I		D		NAME PLATE - EXTENSION				OWENS-ILLINOIS, INC. DRAWING NUMBER
H		C		ALL FINISHED FRACTIONAL DIMENSIONS ± .007	DRAWN RLB	CHECKED	DATE 4-5-73	SCALE FULL
G		B						
F		A	9-25-73	UNLESS SPECIFIED FINISHED SURFACES ROUGHNESS NOT TO EXCEED √	MATERIAL AISI - C1117 C.R.S.			OIS-29-33
E		CHANGES

DRAWING NO. OIS-29-33 CHG. LET. A CHG. BY RLB

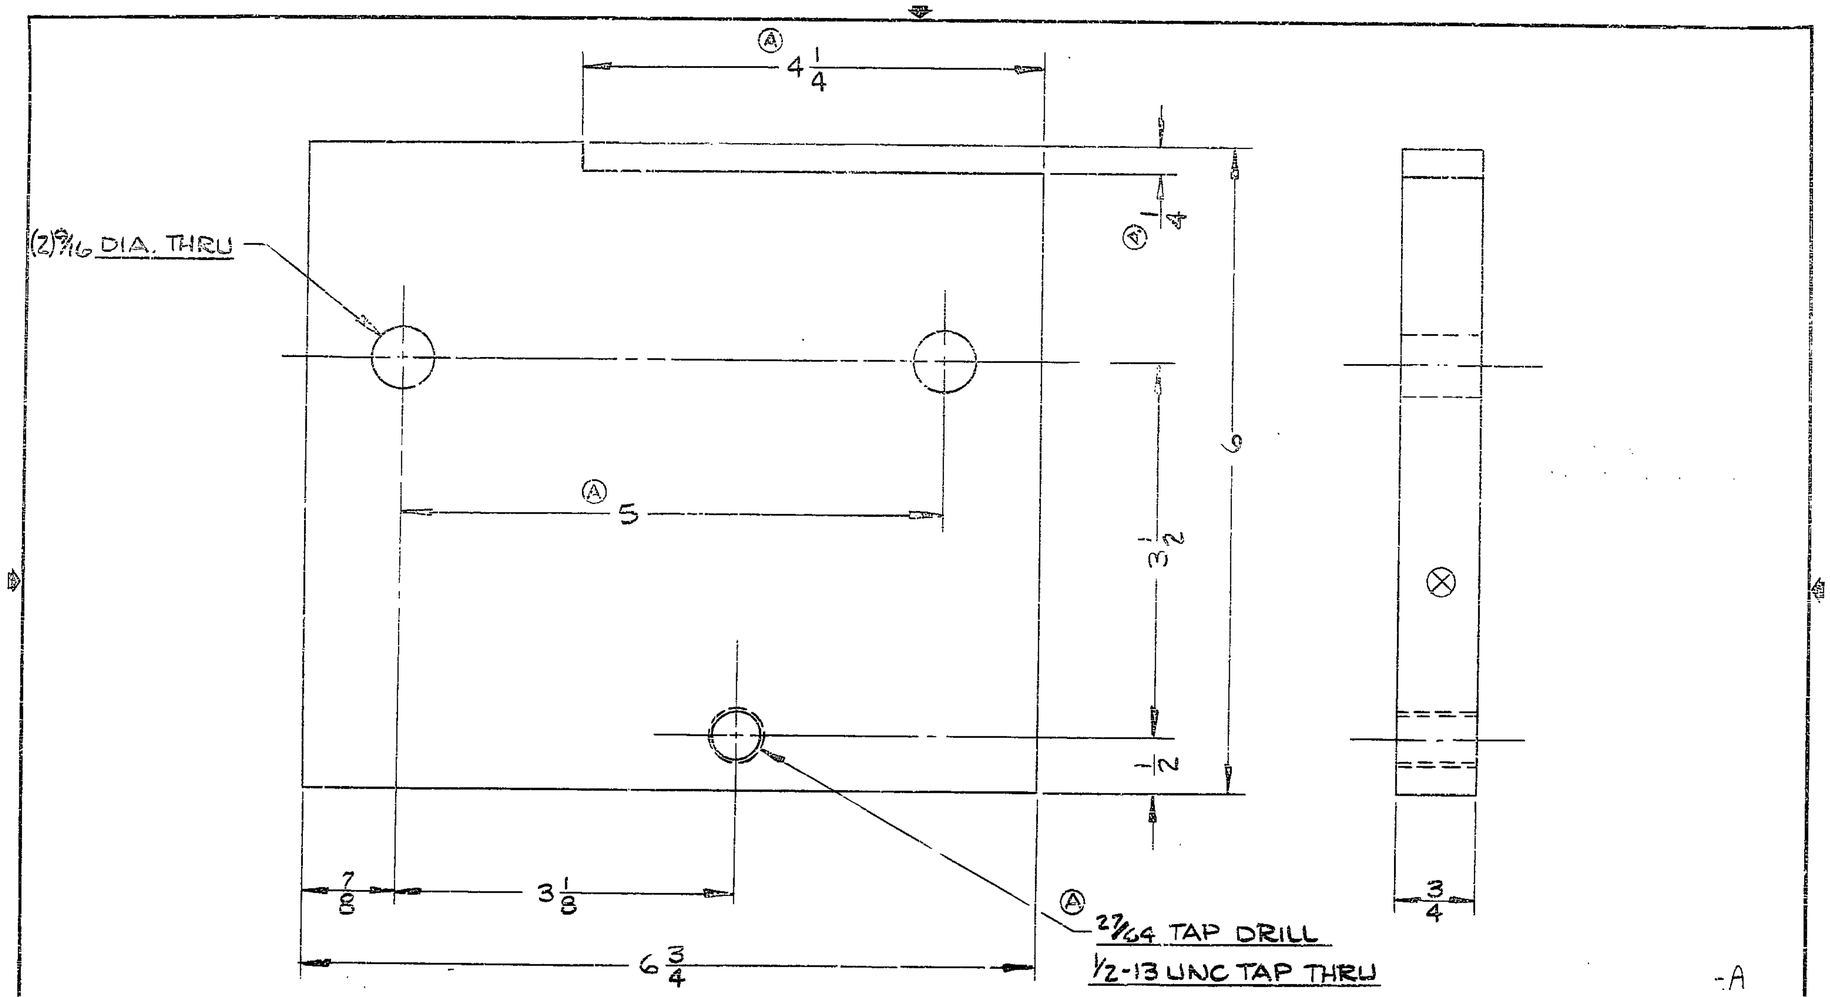
DESCRIPTION OF CHANGE ADDED 1/4" x 4 1/4" NOTCH ; MOVED 9/16 HOLE FROM 3 1/8" TO 5" ; ADDED HOLE DESCRIPTION

REASON FOR CHANGE OMISSION
